**Kay-Fries  
Inactive Hazardous Waste Site  
Operable Unit 1**

Site Number 3-44-023  
Stony Point (T)  
Rockland County, New York

**Record of Decision**

March 1994

FIGURE 6

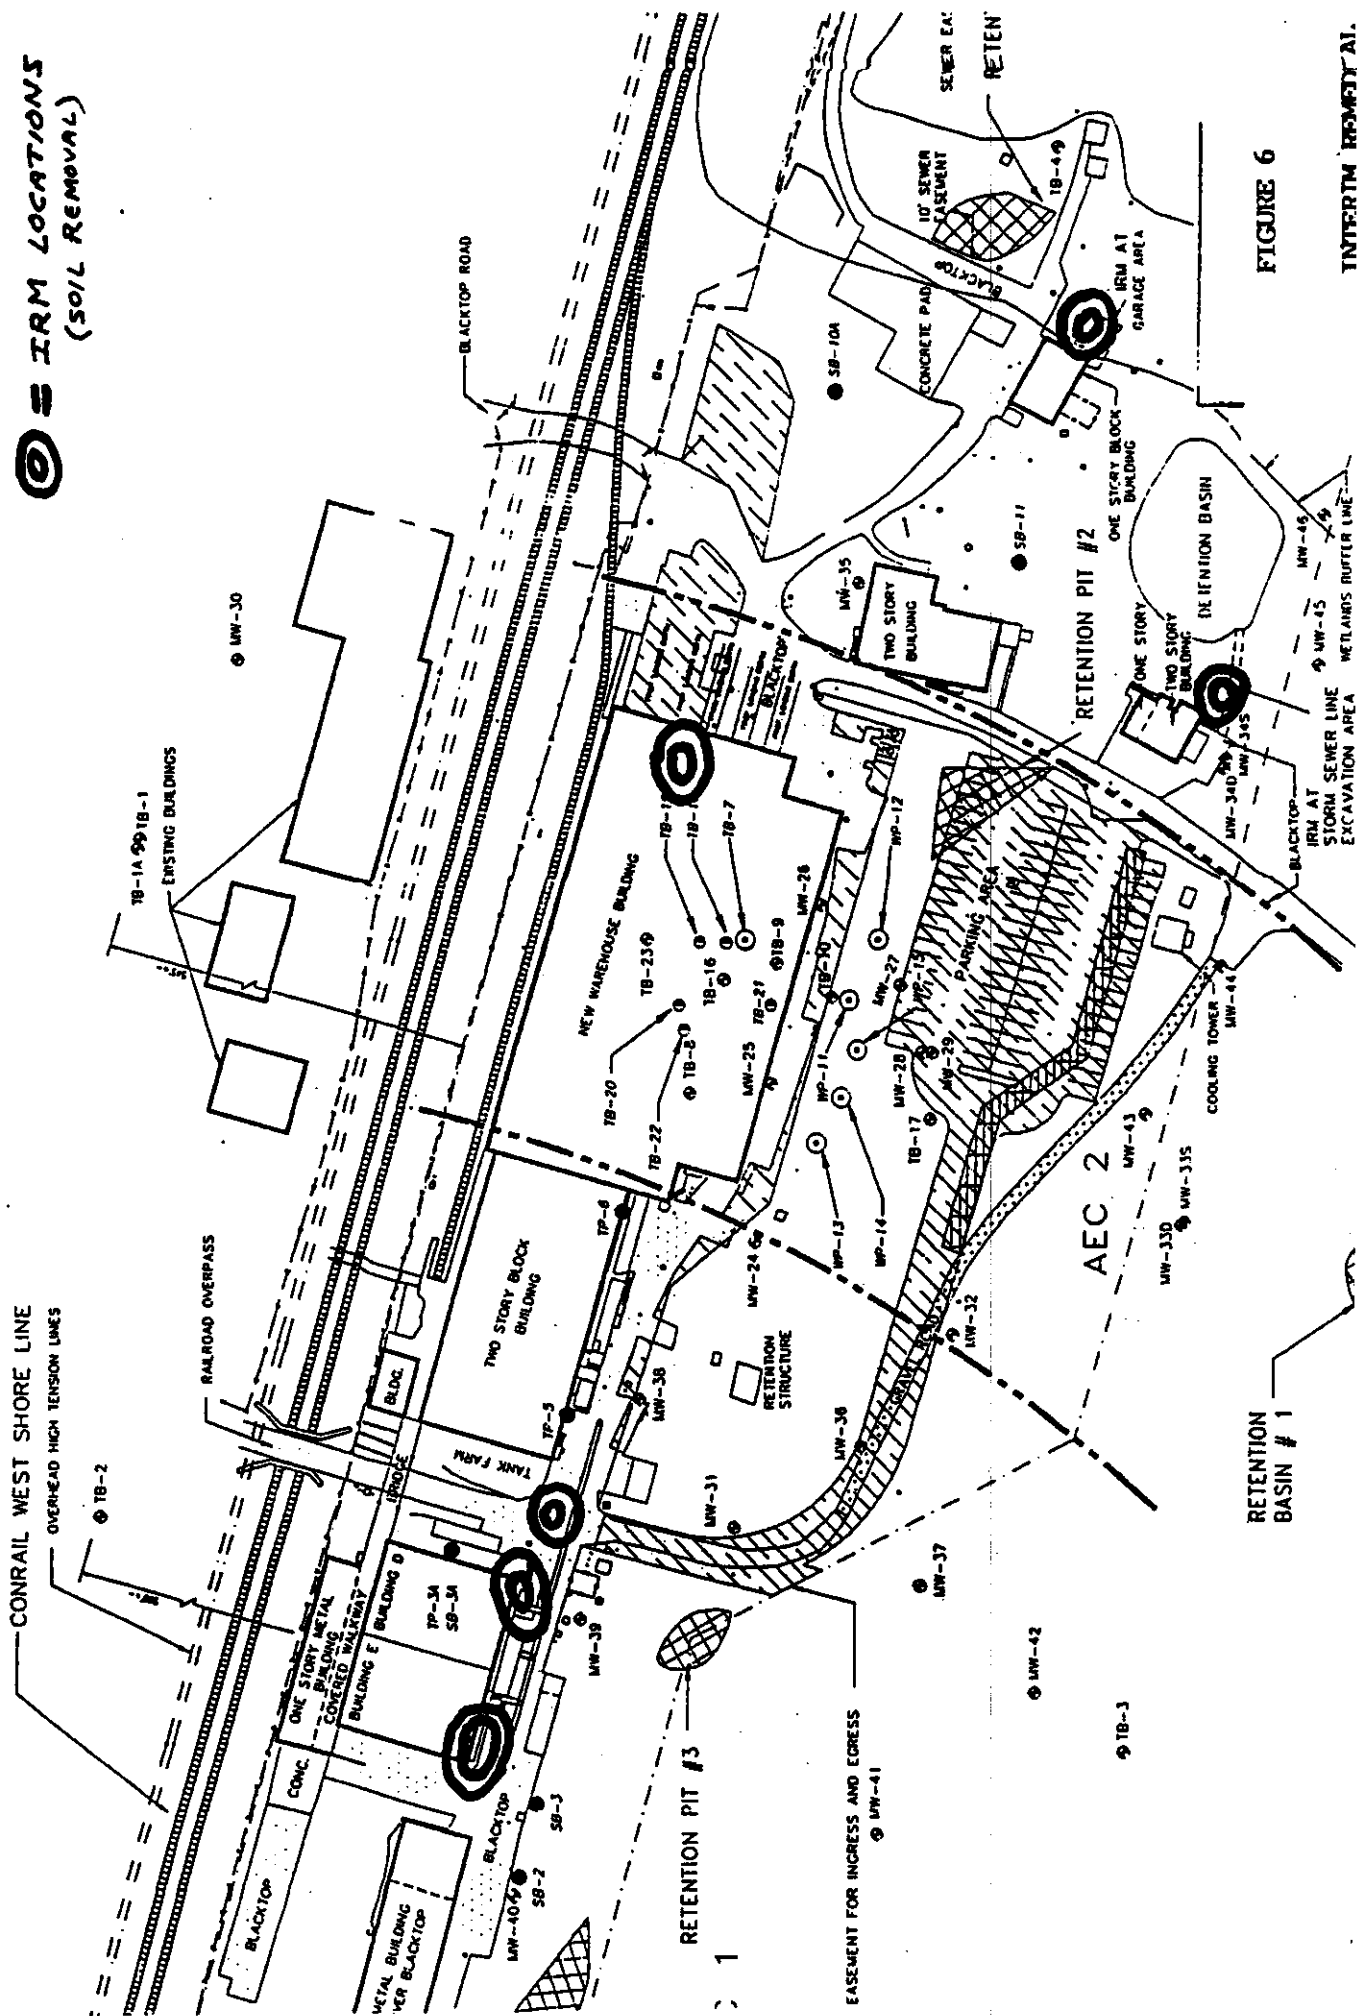
C2. **Question:** Regarding all the soil removal IRMs: What was in those soils, how were the excavations handled, were they tested for Toxicity Characteristic Leaching Procedure (TCLP), where are the records of disposition and where were the soils disposed? Was this soil used to backfill retention pits 2 and 3? If not, where did the backfill come from?

**Answer:** The consultant that performed the RI/FS at the Kay-Fries Site grouped the soil removal actions that have taken place there into five IRMs. These IRMs have been numbered, one through five according to the order in which they were undertaken. There are: IRM No. 1 - Soil Removal at the Foundation for the New Warehouse Building 6; IRM No. 2 - Soil removal north of the Product Development Building for the installation of a storm sewer line; IRM No. 3 - soil removal at Building D; IRM No. 4 - soil removal at Building E; and IRM No. 5 - soil removal north of garage.
